#### PCN#20210212001.1

### Qualification of new Fab site (CFAB) using qualified Process Technology, Die Revision, updated BOMs, and additional Assembly options for select devices Change Notification / Sample Request

PCN Number: 202		210212001.1			PCN Date:			Feb 15, 2021		
Title: Qualification of new Fab site (CFAB) using qualified Process Technology, Die Revisio updated BOMs, and additional Assembly options for select devices										
Customer Contact:			PCN Manager			Dept:			Quality Services	
Pro	Proposed 1 <sup>st</sup> Ship Date:			May 16, 2021		Estimated Sample Availability:			Date provided at sample request.	
Change Type:										
Assembly Site		Assembly Process				$\boxtimes$	Assembly Materials			
🛛 Design			Electrical Specification				Mechanical Specification			
Test Site			Packing/Shipping/Labeling					Test Process		
Wafer Bump Site			Wafer Bump Material					Wafer Bump Process		
🛛 Wafer Fab Site			$\boxtimes$	Wafer Fab Materials			$\boxtimes$	Wafe	r Fab Process	
			Part number change							
	PCN Details

## Construction differences are noted below:

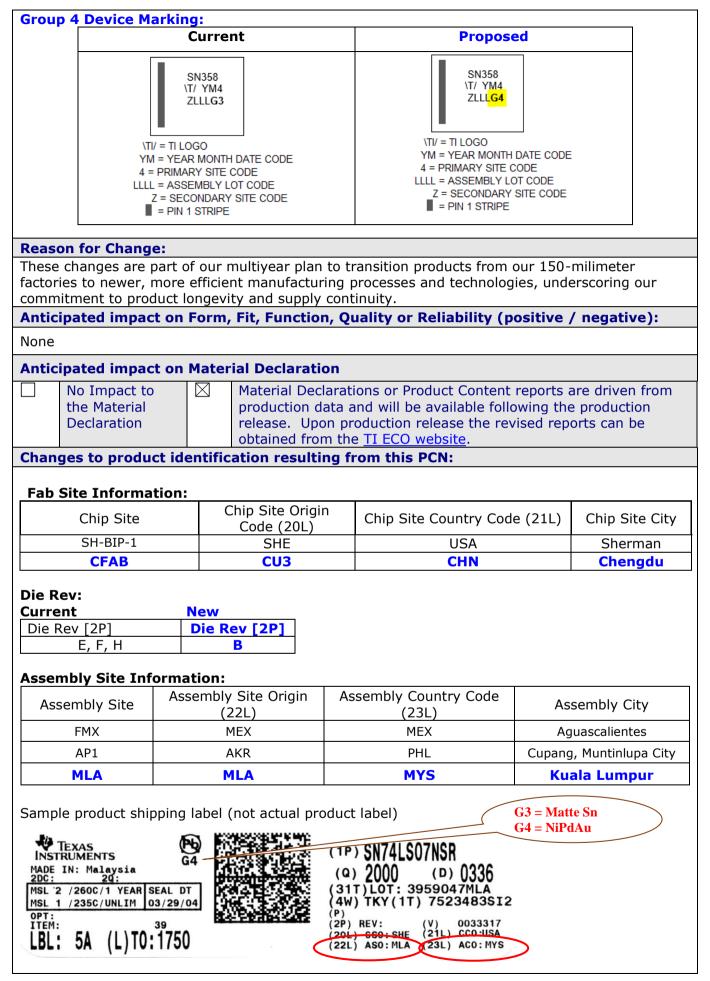
Texas Instruments is pleased to announce the qualification of a new fab using a qualified process technology (CFAB, JI3), updated BOMs, and assembly (MLA) site options for selected devices as listed below in the product affected section.

C	urrent Fab Site	e	New Fab Site			
Current Fab Site	Process	Wafer Diameter	New Fab Site	Process	Wafer Diameter	
SFAB	JI1	150 mm	CFAB	JI3	200 mm

The die was also changed as a result of the process change.

MLA	FMX	AP1	FMX New	<b>MLA New</b>	
Mount						
Compound	4147858	4147858	SID#101375281	4147858	4147858	
Mold						
Compound	4211880	4211880	SID#101380756	4211880	4211880	
Lead finish,	NiPdAu, non	NiPdAu, non				
Prep	RLF	RLF	Matte Sn, non RLF	NiPdAu, RLF	NiPdAu, RLF	
Bond wire,						
diameter	Cu 0.96mil	Cu 0.96mil	Cu, 1.0 mils	Cu, 0.8 mils	Cu, 0.8 mils	
MSL	G4	G4	G3	G4	G4
